MCUI/41/2024 - DEVELOPMENT APPLICATION FOR A MATERIAL CHANGE OF USE (RENOVATION / EXTENSION TO AN EXISTING COMMUNITY CARE CENTRE) AND RECONFIGURATION OF A LOT (ACCESS EASEMENT) - 35A AND 35 NORTH ROAD AND 16 HAGUE STREET, WOODRIDGE, QLD 4114 - LOTS 3 AND 4 RP 126257 AND LOT 62 RP 111108

On behalf of the Vincent Fairfax Family Foundation (VFFF), Urban Advisory has prepared a response to the information request dated 21 August 2024 relating to development application MCUI/41/2024.

*Proposed crossover arrangements*

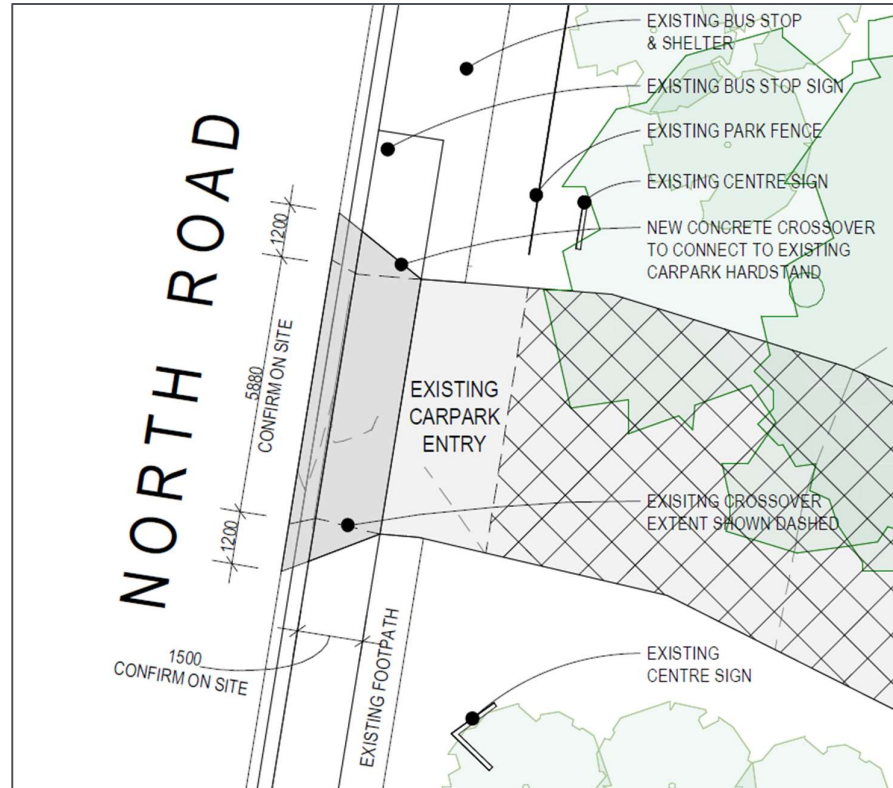
- 3.4 *Amend the proposed plans to notate that the existing crossover to North Road is to be upgraded to a minimum of 6m wide and in accordance with RS-051 (heavy duty).*

*Note: In subsequent correspondence, Council officers revised the specification from RS-051 (heavy duty) to RSD-102 IPWEA.*

Refer to the updated Site Plan (SD100 Revision D) prepared by Hames Sharley Architects. The plan shows a new crossover to North Road, largely based on the RSD-102 IPWEA specification (advised as preferred by the Council) but adapted for the site specific circumstances:

- location and width of the existing access driveway
- proximity of the crossover to the existing bus stop
- location of pedestrian footpath
- location of adjoining property boundary.

The width of the proposed crossover is 5.88m with 2 x 1.2m splays.

Recognising the constraints of the existing built environment, the proposed crossover is considered an appropriate outcome and a significant improvement over the current infrastructure, satisfying the intent of Item 3.4.
